Harbourside Shopping Centre Redevelopment DA (SSD-7874) – Response to Submissions and Department of Planning

We have reviewed the submissions from City of Sydney regarding cycleway upgrades and connections.

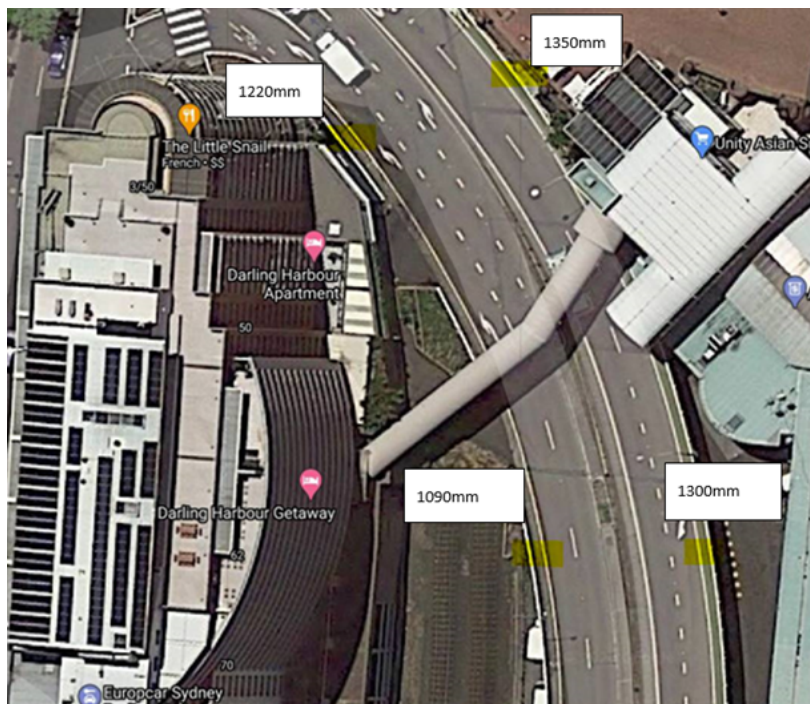
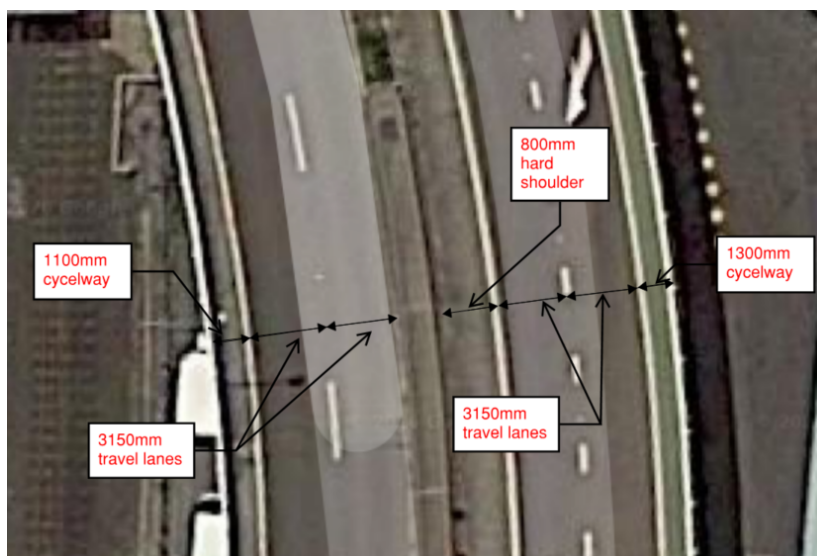
The City's comments regarding bicycle lanes in the previous submission has not been adequately addressed in the RTS, nor is there an indication provided in with respect to the overall commitment to cycling. No cycleway connection improvements are proposed as part of the application and reliance is made on the improvements already made by other developments along Darling Drive.

The City would expect an upgraded and separated cycleway connection from Murray Street/Union Street intersection (major cycleway) to the roundabout adjacent the site that is consistent with the design of the cycleway built south of the roundabout. Access is strongly preferred through an arrangement, which provides a dedicated bicycle entry/exit arrangement without stair access.

There are existing one way, on road cycleways located in both directions of Darling Drive between the roundabout at Harbourside and the Pyrmont Bridge Road intersection. The spatial planning on any cycleway in this location is constraint as they need to be contained within the existing road ramp structure.

We believe that the existing width of these two cycleways range from approximately 1300mm to 1350mm southbound and approximately 1090mm to 1220mm northbound. The typical one way cycleway minimum and desirable widths are 1200mm and 1500mm, respectively.

The image below indicates the arrangement of the vehicle travel lanes and the two, one-way cycleways, with indicative cycleway widths identified.

There are typically two vehicular travel lanes in both directions. The northbound and southbound travel lanes are all typically 3150mm wide. The southbound roadway also contains a hard shoulder approximately 800mm in width. The image below outlines the existing layout.

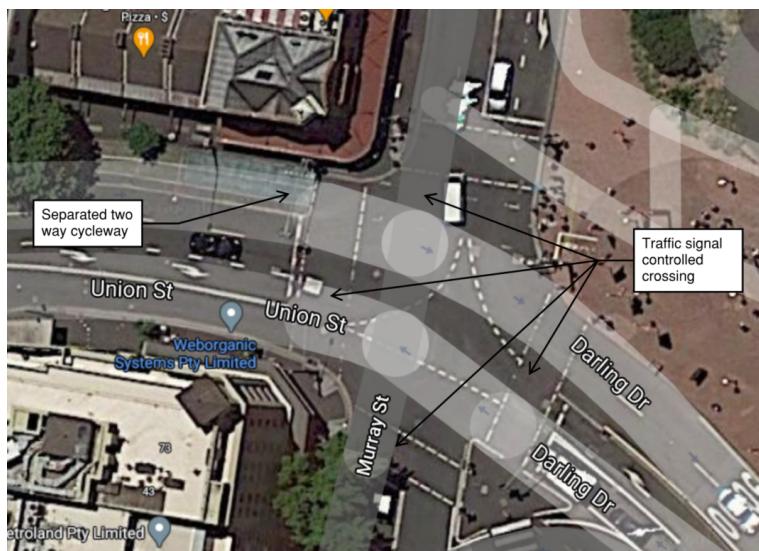
The City considers that upgrades to all pedestrian access points should include the provision for bicycle users also. This includes but is not limited to the following:

- Route 1 – CBD to Pyrmont Bridge
- Route 2 – CBD to Cockle Bay Wharf (north bridge)
- Route 3 – CBD to Cockle Bay Wharf (central bridge)
- Route 4 – Druiitt Street Bridge

The primary connection of this cycle route linking the two way cycleway on Union Street with the Pyrmont to CBD cycle route is a traffic controlled signalised intersection.

The Harbourside development will result in repaving the entry to Pyrmont Bridge. As such, we will explore options in future detailed design stages to create an improved east-west cycle connection at this location.

All four arms of the Pyrmont Bridge Road / Union Street intersection are controlled by traffic controls, as outlined in the image above. As such, we believe that safe connections are already in place to connect the existing Darling Drive cycleway to the Pyrmont to CBD route.
